SYMPTOM:

This rework instruction is to solve audible squeaking noise when TV set is in 'stand-by' mode or 'off'.

CURE:

Place a resistor (Rx) in parallel with 3B34 and 3B60 on the SSB.

- Schematic:

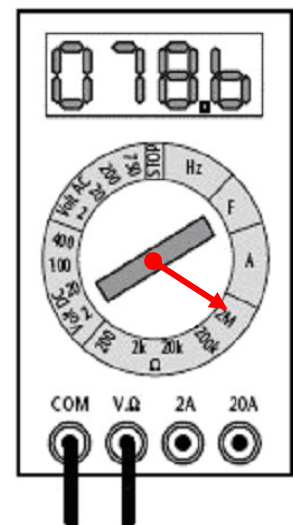
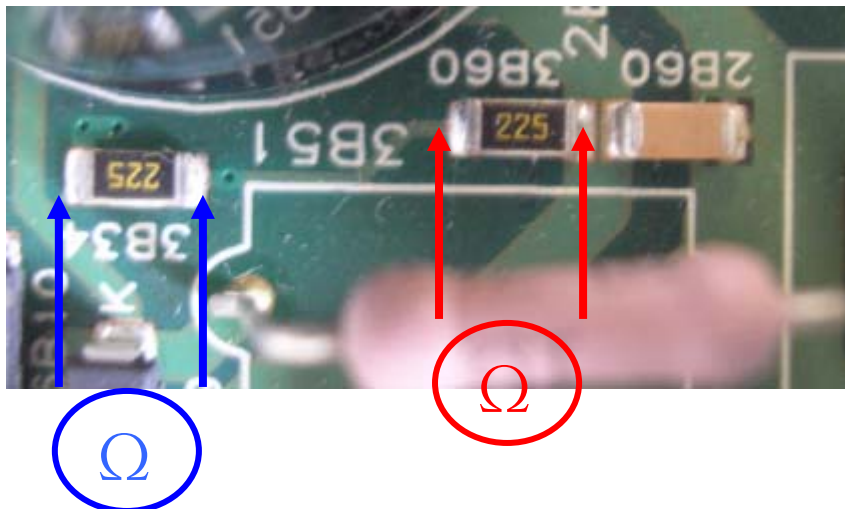
- Place VR37 type resistor, in the following position (see schematic):
 - ➔ from the '+' of the bridge diode 6B04.
 - ➔ to the MOSFET 7B05.
- Type of component:
 - ➔ resistor is VR37 type. Blue body colour.
 - ➔ for value and ordering information, see table.

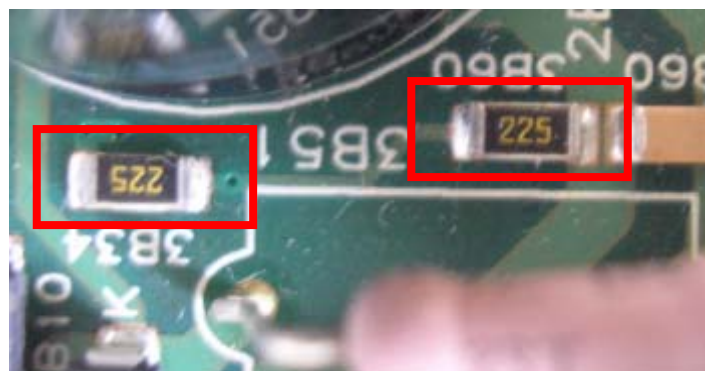
- How to recognize value of 3B34 / 3B60 with multi-meter
 - measure each SMD resistor 3B60 & 3B34 separate.
 - multi-meter into Ohm, biggest range of resistance.
 - see picture:

Remark:

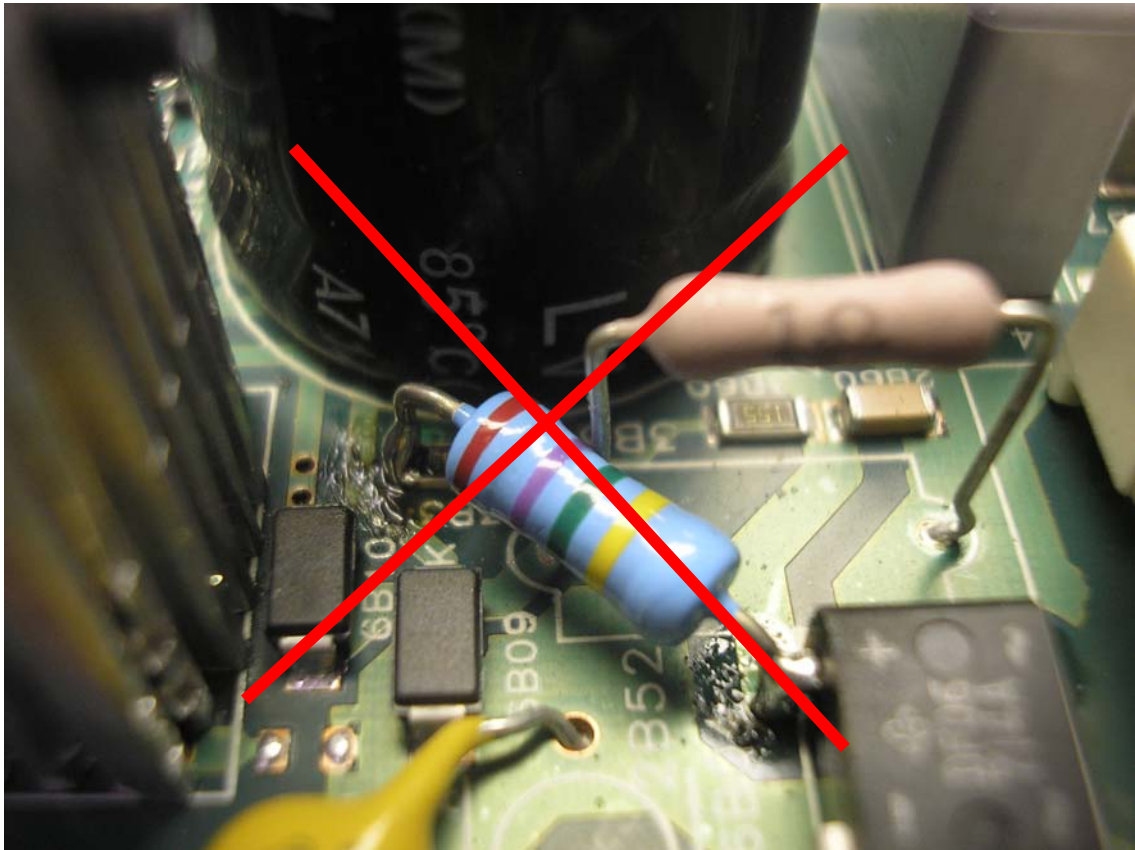
Not OK!

Reason: Both resistors are touching each other.

This change is in the primary part. Make sure the soldering is done with the necessary precautions.
